**Refuse Deflector Installation for
McNeilus or Agility 60 DGE CNG Roof
Mounted Systems**

Date: October 13, 2017
Bulletin Name: FEL-TSIB-052
Model: Contender FEL 87
Model Year: 2011 - 2018
Units Affected: McNeilus or Agility CNG
 Roof Mounted Systems

Figure 1

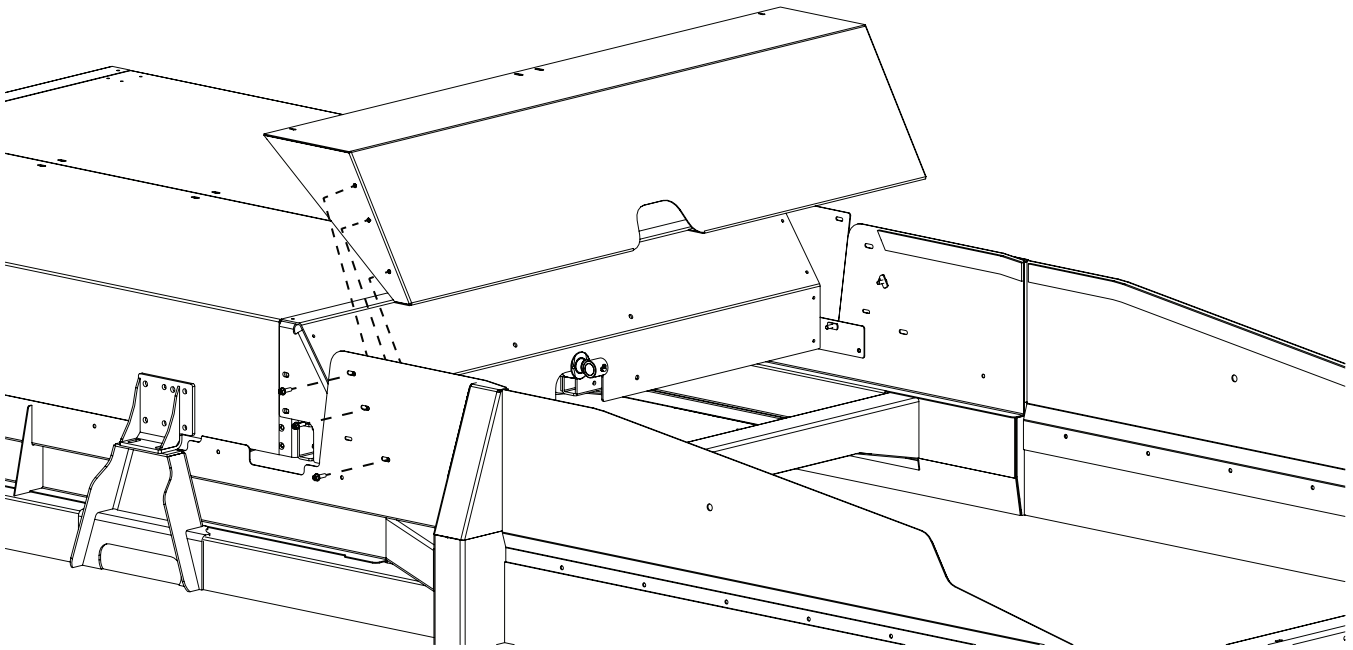
3. Remove and discard the existing refuse deflector and hardware (Figure 1).

Figure 2

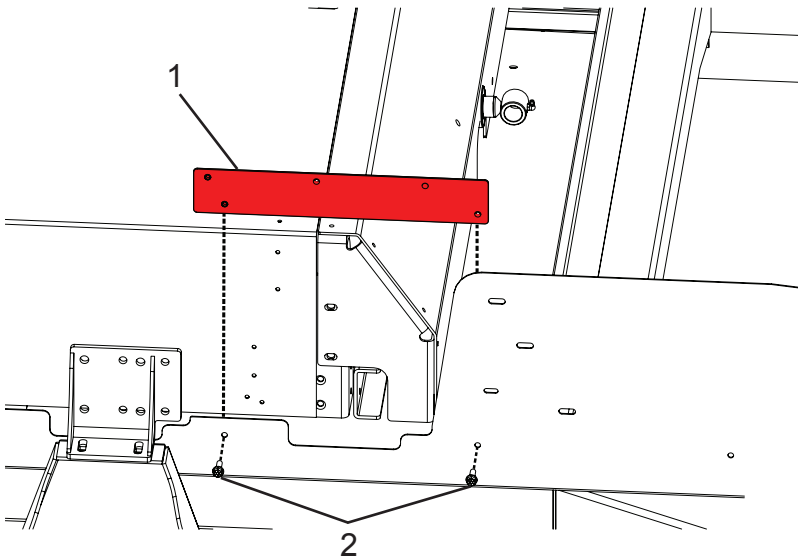
4. Starting on one side of the vehicle, install the rectangle cover piece ensuring the weld nuts are to the inside (Figure 2, Item 1). **NOTE:** Street side (PN 1572664) and curb side (PN 1572666) have different cover pieces.
5. Install (2) bolts (PN 1243637) to attach the cover piece to the vehicle windguard (Figure 2, Item 2).

6. Use a torque wrench to torque bolts to 33 ft.-lbs.
7. Repeat Steps 4 through 6 on the opposite side of the vehicle with the appropriate rectangle cover piece.

Figure 3

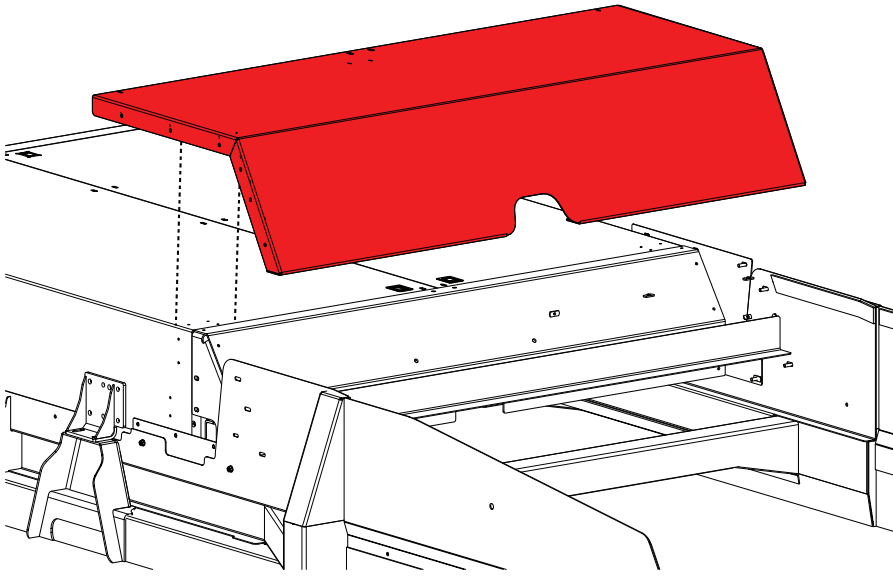
8. Attach the slings and overhead crane to the refuse deflector weldment cover piece (Figure 3) (PN 1572662).
9. Move the refuse deflector weldment cover piece into position at the roof mounted CNG system and line up the refuse deflector weldment cover piece so that you can install bolts in the three diagonal bolt slots on either side of the vehicle (Figure 3).

Figure 4

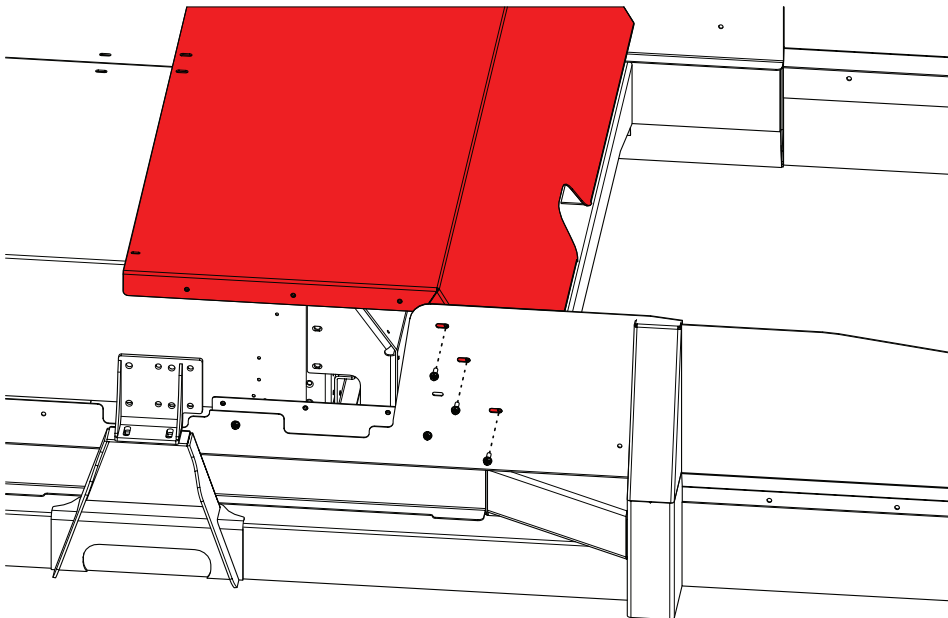
10. Install bolts in the three diagonal bolt slots on both sides to secure the refuse deflector weldment cover piece to the windguards (Figure 4).
11. Use a torque wrench to torque the bolts to 33 ft.-lbs.

Figure 5

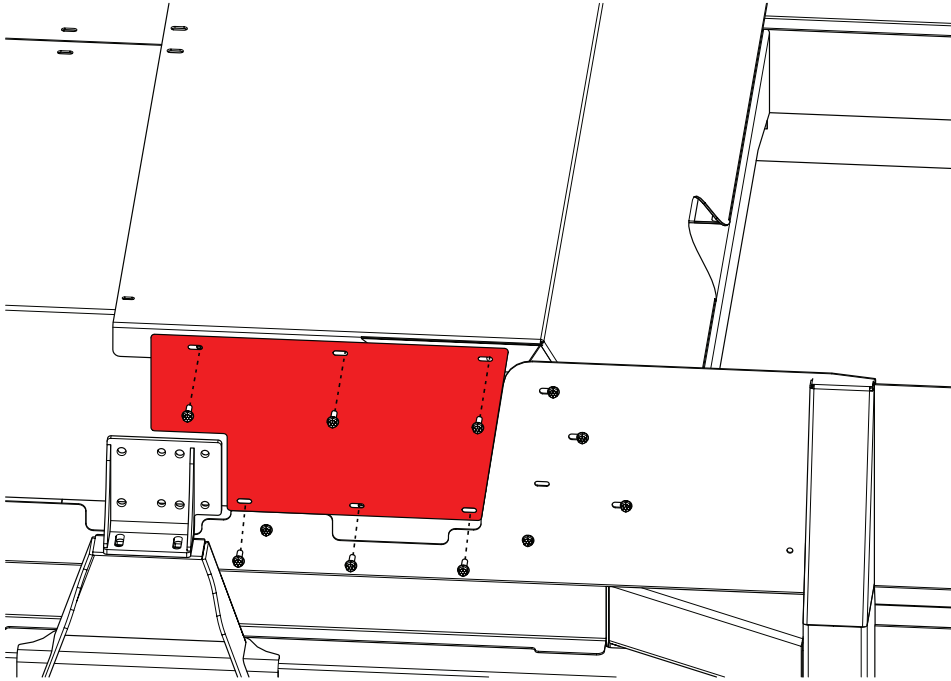
12. Starting on one side of the vehicle, install the large side cover piece (PN 1572667) so that it will attach to the refuse deflector weldment cover piece in three areas and to the rectangle cover pieces in three areas (Figure 5). **NOTE:** The side cover pieces go on the outside of the refuse deflector weldment cover and the rectangle cover pieces.
13. Use a torque wrench to torque the bolts to 33 ft.-lbs.

Figure 6

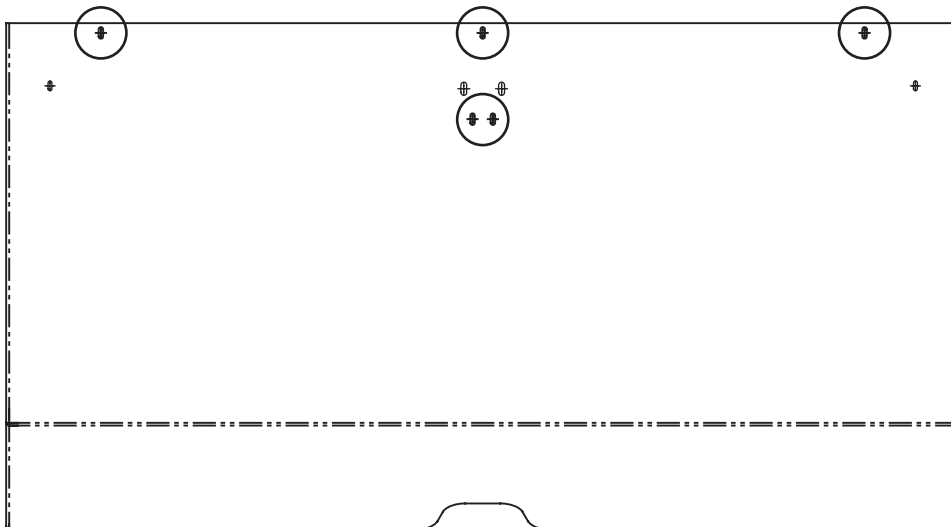
14. Repeat Steps 12 and 13 on the other side of the truck to install the second large side cover piece (PN 1572667).
15. Install the correct bolts across the top of weldment cover piece. The number of bolts and specific holes used will be based on if the CNG system is McNeilus or Agility. Figure 6 (McNeilus) and Figure 7 (Agility) detail the specific holes for each system.
 - McNeilus CNG system = Bolts PN 0120023, quantity 5
 - Agility CNG system = Bolts PN 1243637, quantity 4
16. Use a torque wrench to torque the McNeilus bolts to 9 ft.-lbs.
 - Use a torque wrench to torque the Agility bolts to 23 ft.-lbs.
